**Meeting of the Central Valley Flood Protection Board
August 24, 2012**

Staff Report – Encroachment Permit

Dixon Regional Watershed – Joint Powers Authority

Dixon Main Drain and V-Drain Project, Solano County

Figure 1
Profile Main Drain and V Drain

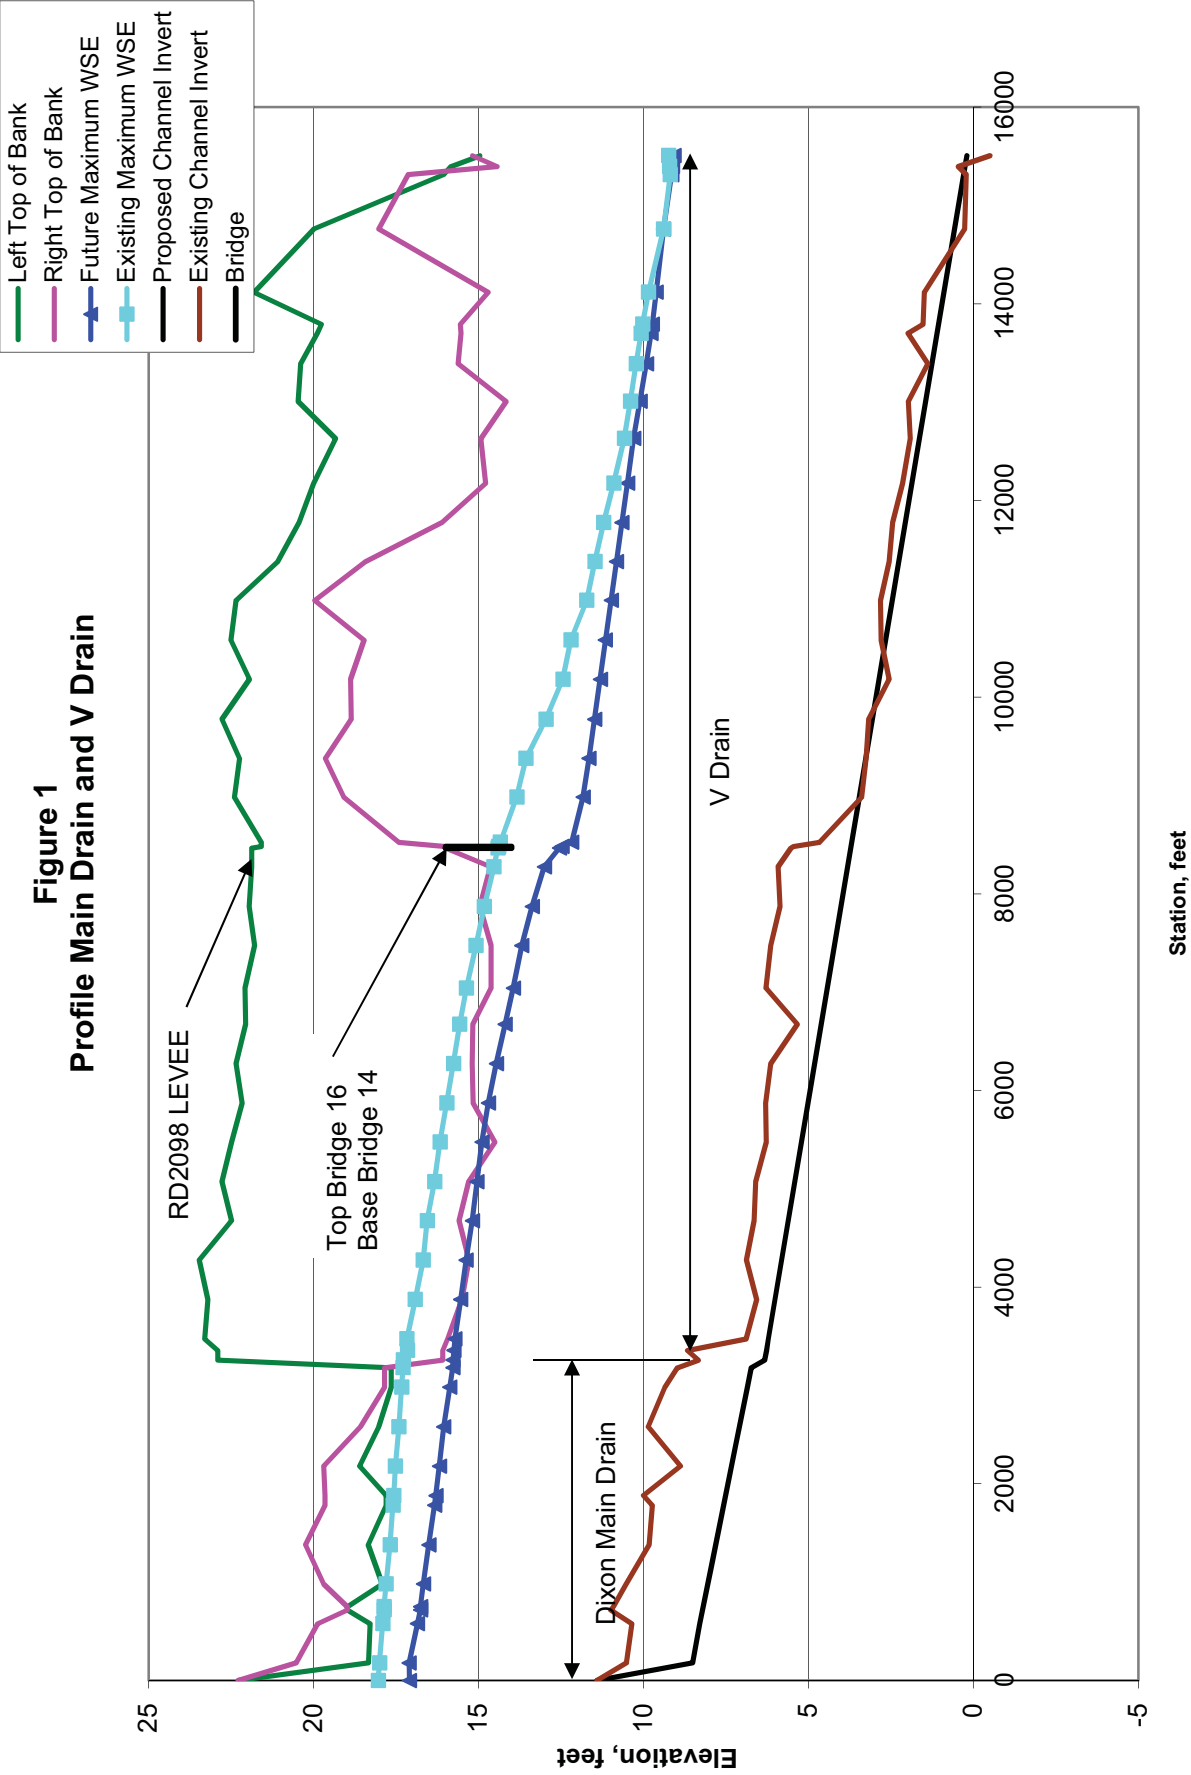
The model resulted in a profile (Attachment E) showing the existing and proposed channel inverts, water surface elevation (WSE) for the existing and future conditions, and bank elevations. As shown in the profile the future water surface elevation is lower than the existing water surface elevation at all locations along the channel.

Figure 1 presents a profile of the channel showing the existing and proposed channel invert along with the channel banks. It shows the water surface elevations for the existing channel flowing at its existing average capacity of 240 cfs in the Main Drain and 1,132 cfs in the V-Drain. It also shows the water surface elevation for the enlarged channel flowing at the target capacities of 615 cfs in the Main Drain and 1,518 cfs in the V-Drain. As shown in Figure 1, the future conditions water surface is lower at all locations along the channel than the existing conditions results. The bridge crossing at the V-Drain is also shown on Figure 1. Bridge elevations were taken from a topographic survey. The bridge deck is at elevation 16.0 feet and the bottom of the bridge is 23 inches below the deck. The water surface elevation of the enlarged channel at the target capacity is below the bottom of the bridge.

Figure 2
Section 185 Feet Upstream of Bridge

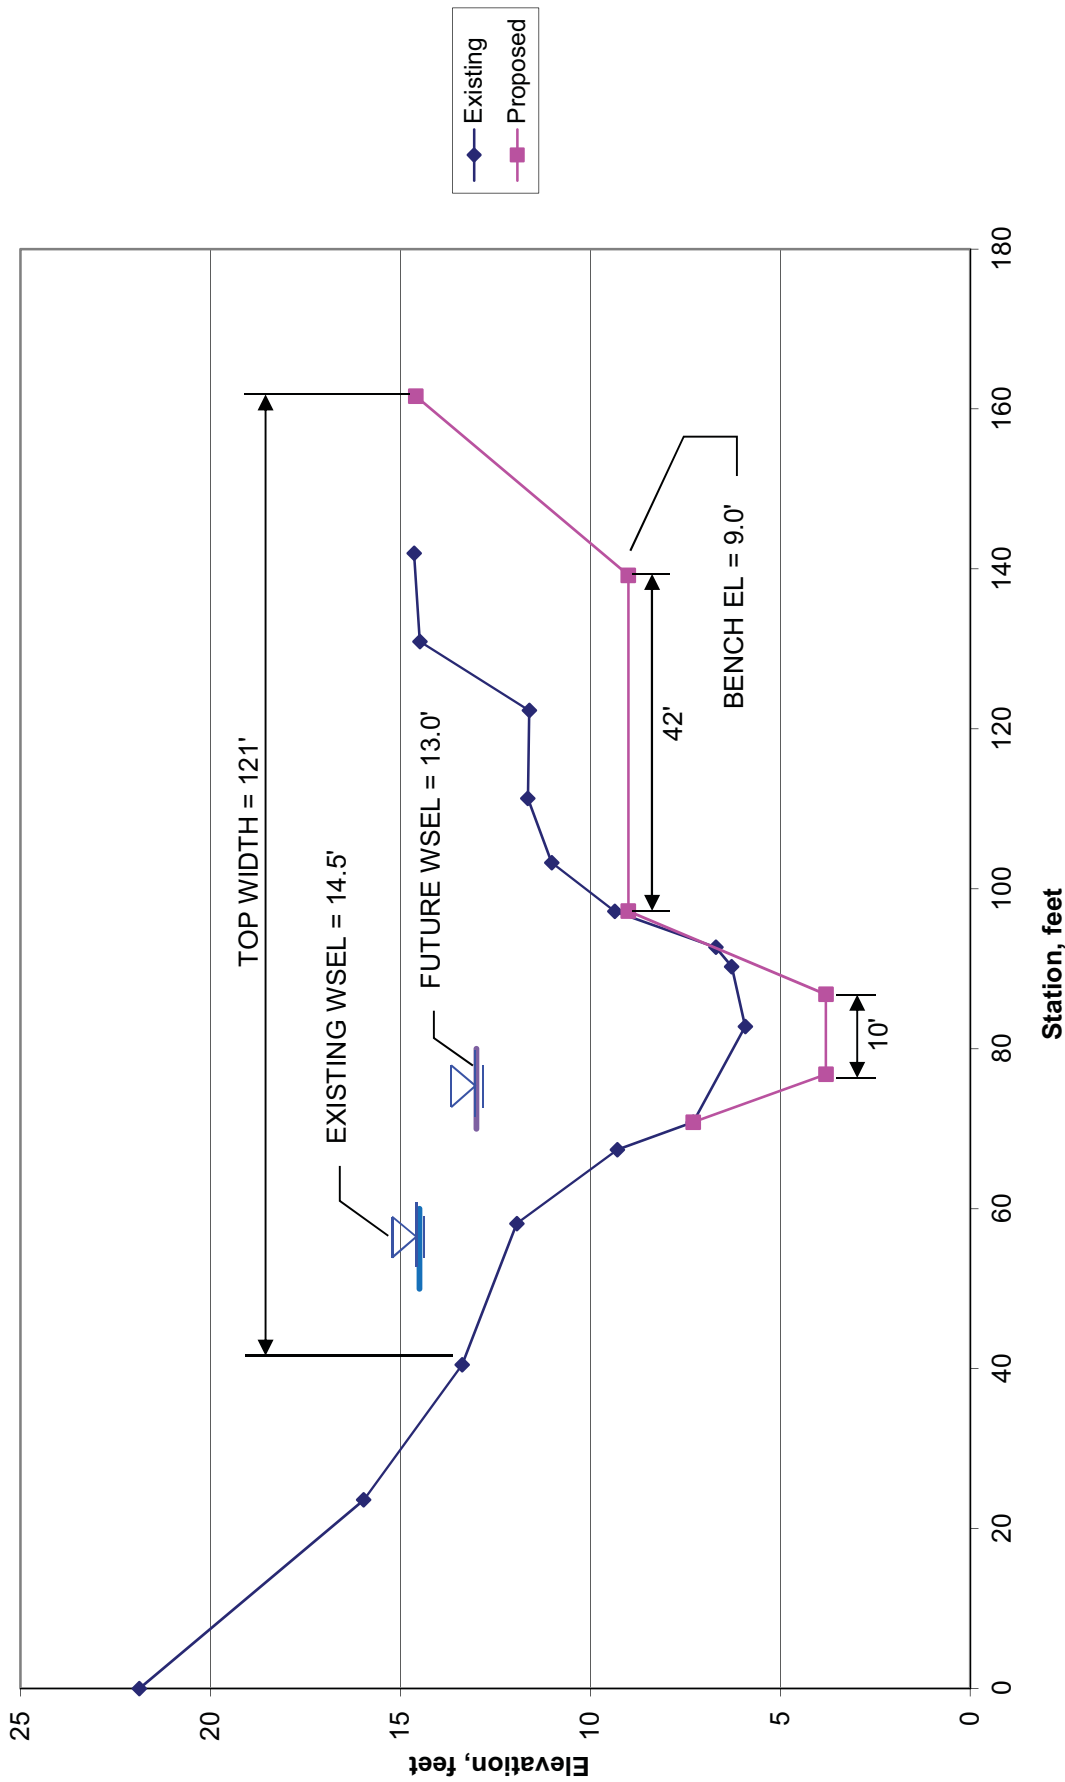
Figures 2 and 4 in the hydraulic study show the cross sections of the VD upstream and downstream of the bridge. In these figures you can clearly see the low flow channels and maintenance benches. Again at both cross sections the future WSE is lower than the existing.

Figure 2 shows the existing and enlarged cross section of the V-Drain approximately 185 feet upstream of the bridge. The proposed channel cross sections north of the bridge have a 10-foot wide low flow channel with 2:1 side slopes. There is a 42-foot wide maintenance bench at elevation 9.0. This bench will be above the tidal elevation and will be dry during the summer so that it can be mowed. The side slope above the maintenance bench is 4:1. As shown on Figure 2 the maximum water surface with the enlarged channel at target flows is about 1.5 feet lower than the existing condition channel flowing at its existing average capacity.

Figure 3
Section at Bridge

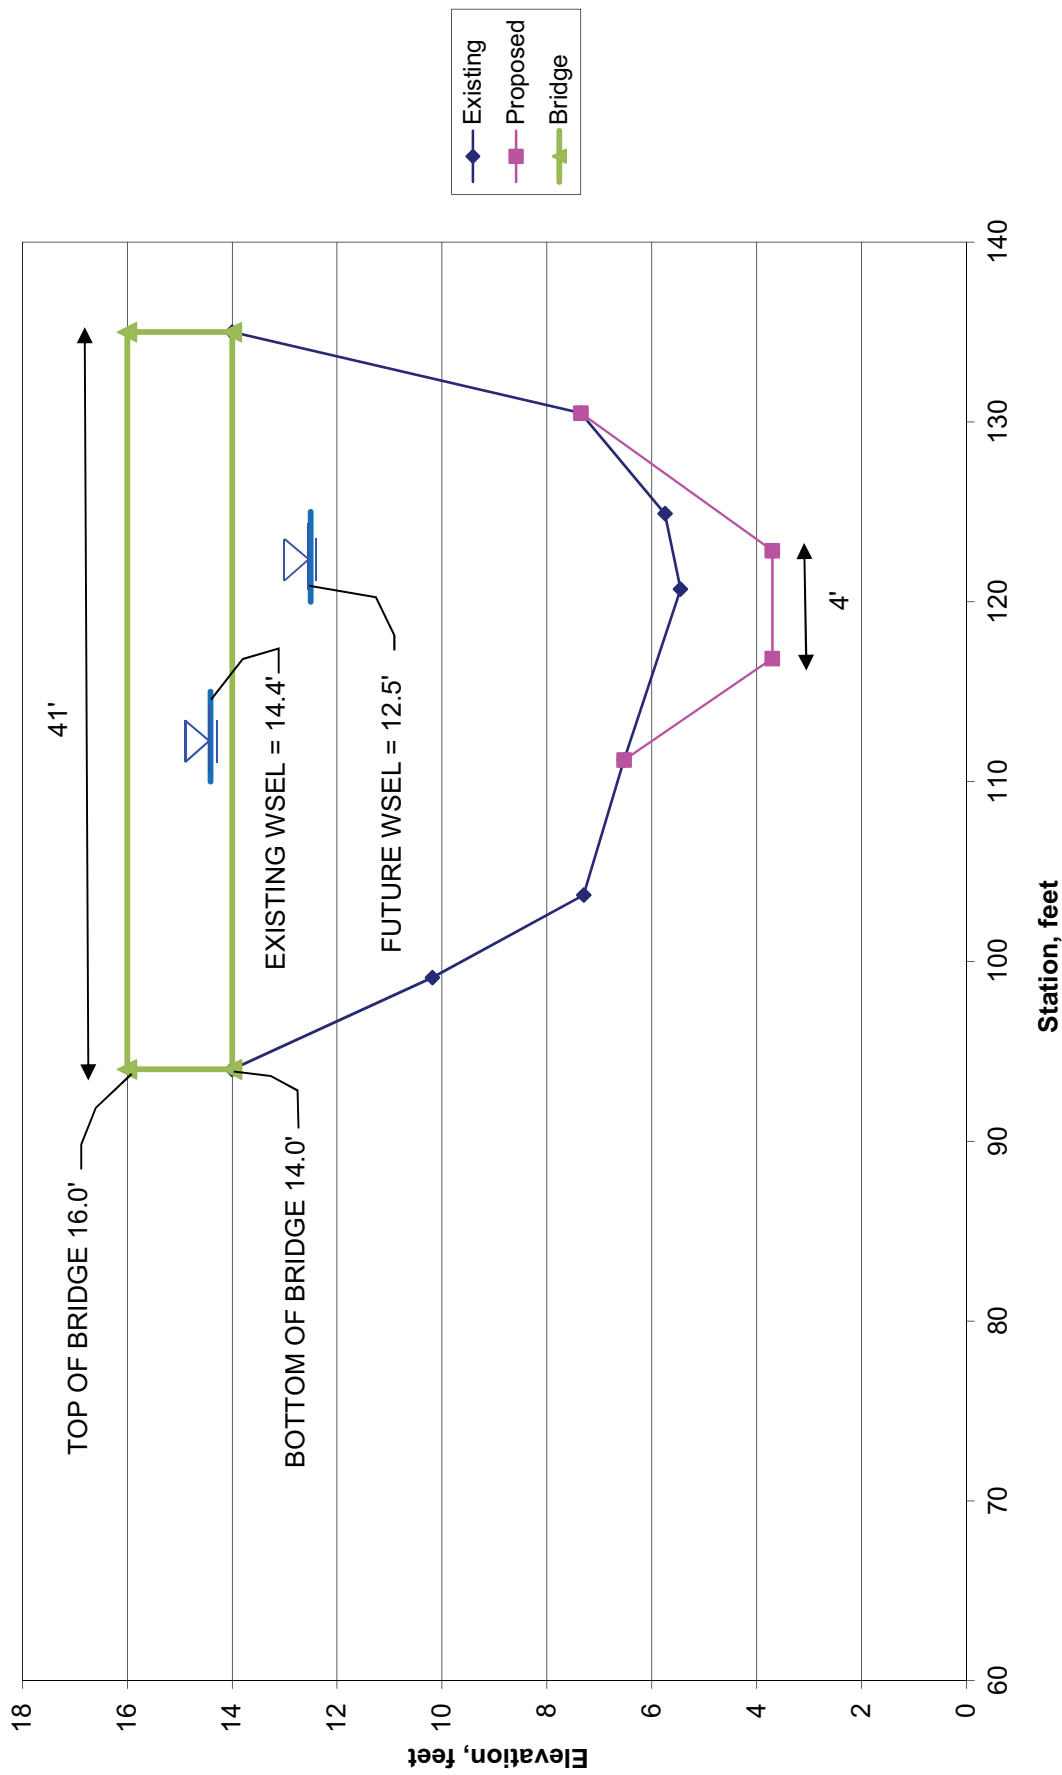
Figure 3 shows the channel section at the bridge. The channel will not be widened at the bridge; it will only be deepened approximately two feet along the invert. Model results show the maximum water surface at the target flows after the project is constructed will be below the bottom of the bridge and about 1.9 feet lower than the existing condition channel flowing at its existing average capacity. The modeled channel velocity at the bridge section in the existing condition is approximately 4.4 feet per second. In the proposed conditions model it is approximately 6.8 feet per second. Because of this higher channel velocity at the bridge, the channel will be lined with rock rip-rap to prevent scour.

Figure 4
Section 500 Feet Downstream of Bridge

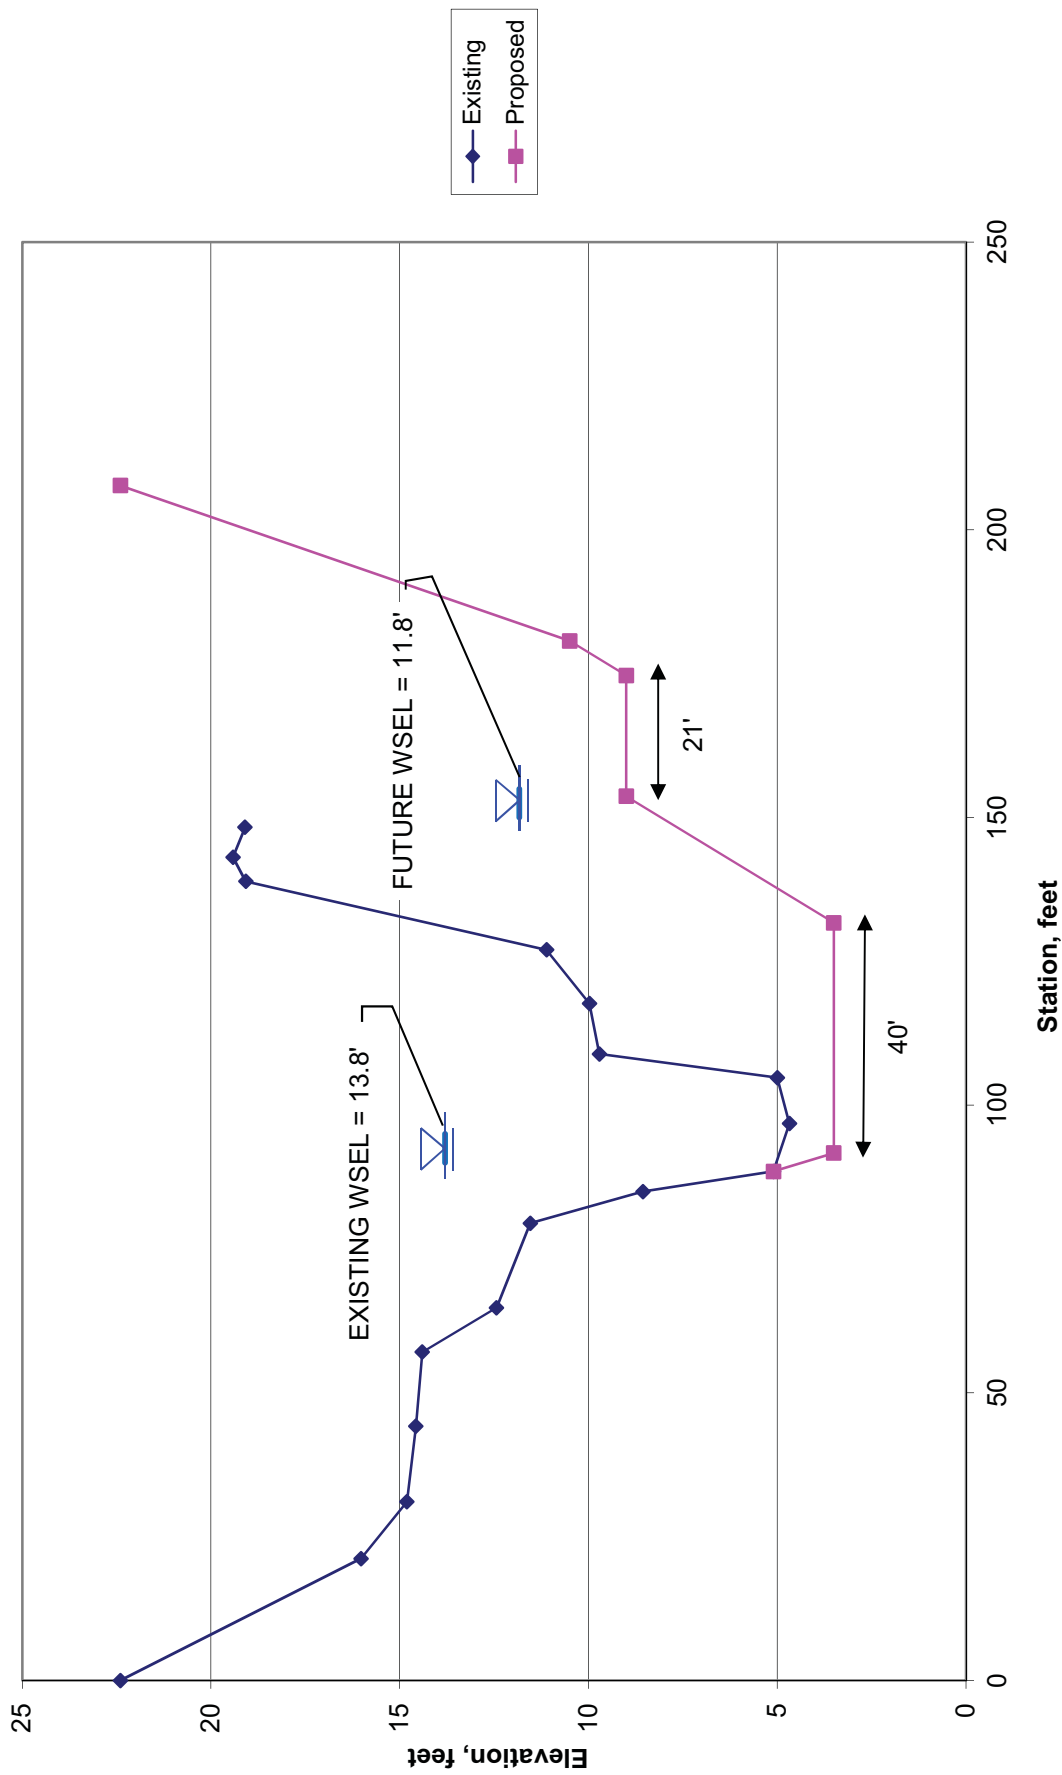
Figure 4 shows the existing and enlarged cross section of the V-Drain approximately 500 feet downstream of the bridge. The proposed channel cross sections south of the bridge have a 40-foot wide low flow channel with 2:1 side slopes on the east and 4:1 side slopes on the west. There is a 21-foot wide maintenance bench at elevation 9.0. The channel south of the bridge experiences more tidal inundation; however this bench will facilitate channel cleaning and maintenance. The side slope above the maintenance bench is 4:1 and the side slope of the adjacent high line canal is 2:1. As shown on Figure 4, the maximum water surface with the enlarged channel at target flows is about two feet lower than the existing condition channel flowing at its existing average capacity.
